SUBJECT: DEMONSTRATION / DELIVERY HOLD - Safety Recall 16S30 - *Supplement #1*
Certain 2013-2015 Model Year C-MAX and Escape, 2012-2015 Focus, 2015 MKC
and Mustang, and 2014-2016 Transit Connect Vehicles
Side Door Latch Replacement

New! REASON FOR THIS SUPPLEMENT

- **Parts ordering information** – Beginning the week of January 30th, secondary P&A codes will be included in the one for one replenishment process.
- **Technical Information** – Added clarification for the child lock switch in Transit Connect vehicles.
- **Dealer Q&A** – The updated Q&A includes additional information regarding parts ordering information.

FIGURE 8

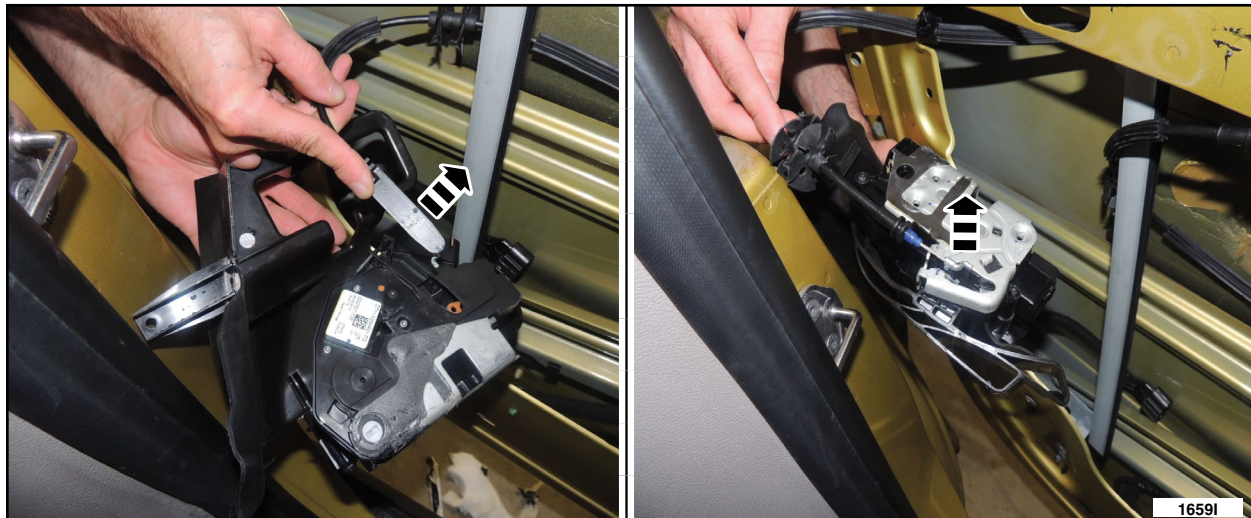
NOTE: When installing the new sliding door latches, align the child lock actuator with the slot in the sliding door before installing the sliding door latch bolts.

9. To install *new* sliding door latches, reverse the removal procedure.
